Subject: Chamber Construction Manual
Posted by [Clemens Adler](#) on Thu, 25 Mar 2004 08:24:30 GMT
[View Forum Message](#) <> [Reply to Message](#)

I updated the chamber construction manual (to version 1.1).

1) [image001.gif](#), downloaded 627 times

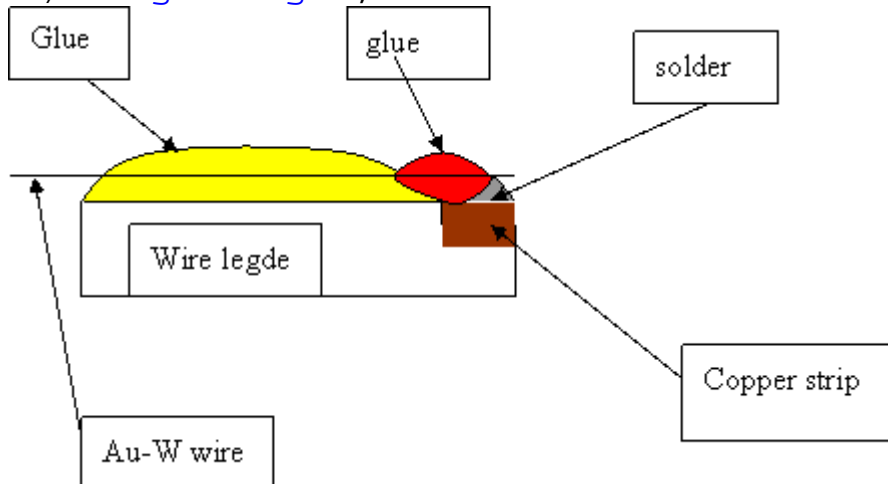
2. An suggestion: Oleg suggests to put some glue to between the glue which holds the anode wire on the wire ledge and the copper strip where the wire is soldered (see attached picture by Oleg).

This should prevent the breaking of the anode wire that we experienced at Heidelberg (see previous messages).

"after soldering of anode wires we put glue (red color) to fix the wire, solder and copper

strip together. It is need to remember that we have to safe a clean place on the copper strip to solder HV cable."

We also had this idea and did it on some chambers, but after discussion with Joerg at GSI, who never had any similar problem we thought that probably sanding the wire ledge edges is good enough and will solve the problem.

Another problem was that we wanted the glue to be cured before we cut the wires, and then we loose 1 day. This is probably not so critical, since at least in Heidelberg and Dubna where not too many people are involved in cahmber building one can find something else to do during this day.

So I would like to hear from GSI (Joerg) and Bukarest (Mihai) what they think. Since we have not put anodes on a chamber since a while due to technical difficulties with machiniery in our lab, I cannot tell at this moment what our experiences with sanding the wire ledges are. I will, therefore, not add this into the construction manual, until there are some more opinions about this additional step.
